Reactor Oversight Process
Task Force FAQ Log
For the August 29, 2012
NRC Public Meeting

**NRC Response to
FAQ 12-01 (Withdrawn) re. Columbia DG3 Failure
For August 29, 2012 ROP WG Meeting**

NRC comments on
FAQ 12-03- St. Lucie Unplanned Scram with Complications
For August 29, 2012 ROP WG Meeting

FAQ 12-04 (Proposed)
HRA Related Occurrences (Generic)

Figure 1, Load and current profile during DG3 Operation on 2/28/10

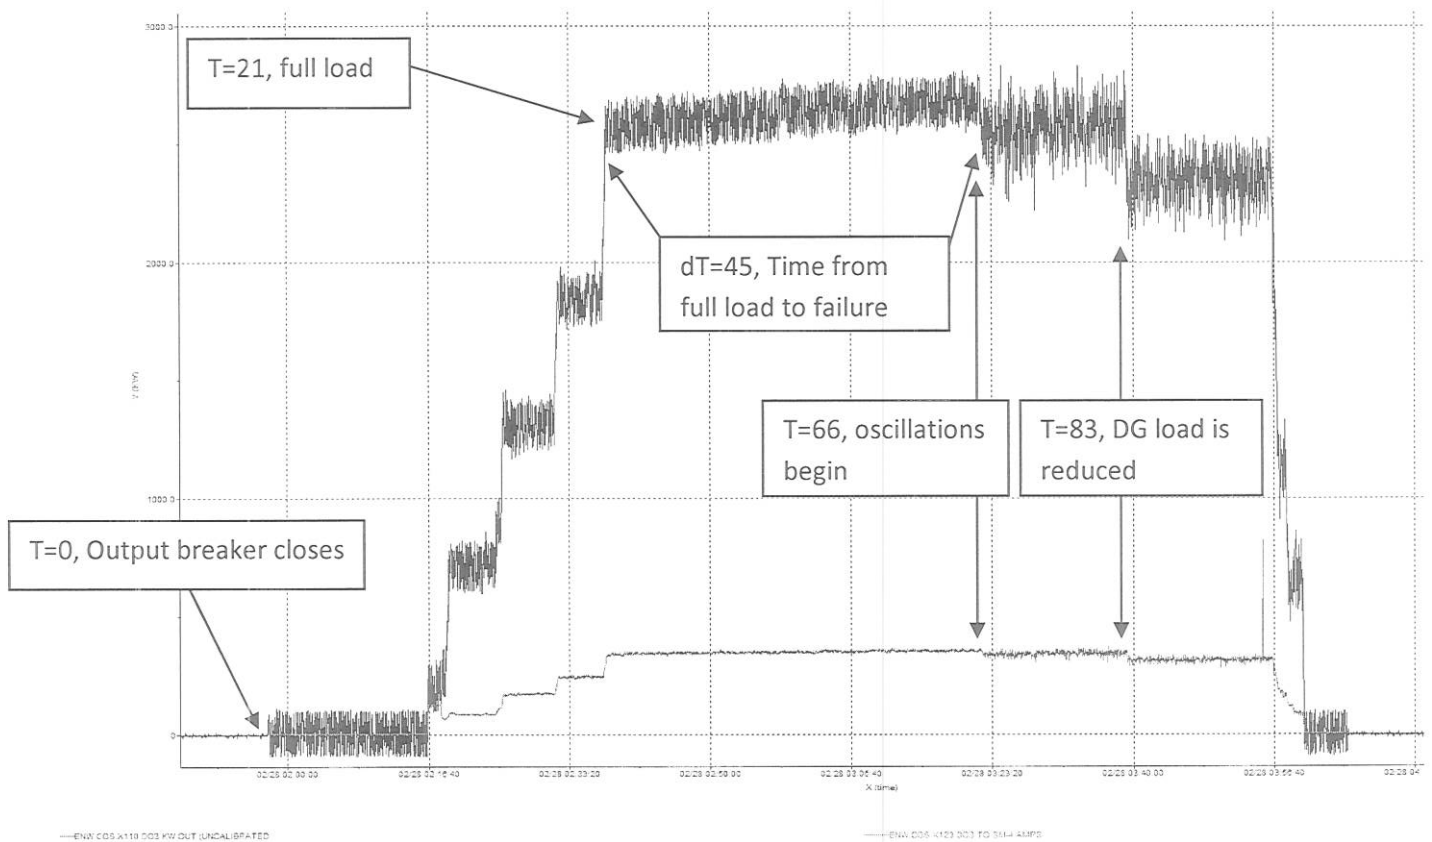
On February 28, 2010, CGS was testing an Emergency Diesel Generator (EDG). Refer to figure 1 for Load and Current trace of the subject event. The EDG successfully started, the EDG output breaker successfully closed (T = 0 minutes), the EDG successfully load sequenced up to fully loaded (T = 21 minutes), after 45 minutes the EDG experienced unexpected load oscillations of 350 kw (T = 66 minutes), after 17 minutes the load was lowered (T = 83 minutes) and the 350 kw oscillations were observed to continue another 16 minutes of operation until the EDG was unloaded (T = 99 minutes) and shut down.

Because Figure 1 data is more reflective of an EDG failure-to-run for its mission time rather than a loading failure, the EDG failure at Columbia should have been reported as a failure-to-run.
